#### V2500-A1 PROPULSION SYSTEMS SERVICE BULLETIN

This document transmits Revision 1 to Service Bulletin EV2500-72-0430 and Revision 1 to the Supplement

# ENGINE - HIGH PRESSURE TURBINE FIRST STAGE DISK METERING PLUG REPLACEMENT

V2500-ENG-72-0430

Location of Metering Plug in Hub Assembly Turbine Stage 1 Figure 1

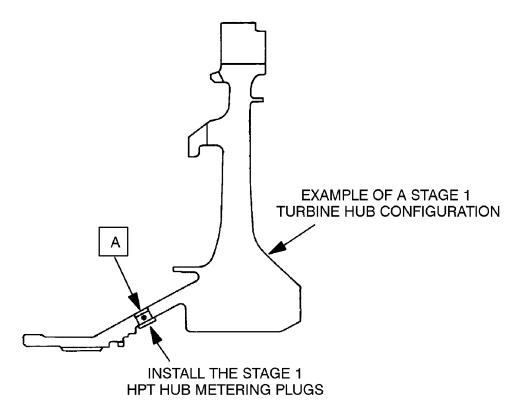
- (1) Remove the 1st Stage Disk Metering Plugs P/N 2A2181 (12 off) from the Turbine Rotor Assembly, 1st Stage (see Reference (4) Chapter Section 72-45-00).

- (2) Measure the Metering Plug holes in the Turbine Hub.
  - (a) If the hole diameter is between 0.377 in. (9.576 mm) and 0.383 in. (9.728 mm) accept and record the dimensions.

- (b) If the hole diameter is between 0.384 in. (9.754 mm) and 0.387 in. (9.830 mm) accept part for select fit only and record the dimension.
  - (c) If A. or B. does not apply, perform one of the following:

- (i) If only one hole does not meet requirements in A. or B. identify the hole location, assembly requirements will allow one plug not to be installed if hole diameter is out of limits. This must be recorded in the engine build records.

- (ii) If more than one hole does not meet requirements in A. or B. contact IAE.
- (3) If all fits are acceptable, use IAE tool P/N IAE1P16494 or IAE1P17763 or other suitable drift to install and seat all 12 (or 11 depending on requirements reference 2. C. (1)) new stage 1 Metering Plugs through the rear bore of the hub into the inner diameter holes of the stage 1 Turbine Hub. Make sure the rear side of the Metering Plug tab touches the outer diameter surface of the Hub. See Figure 1.

ALL FOUR TANGS MUST PROTRUDE THROUGH DISK AS SHOWN
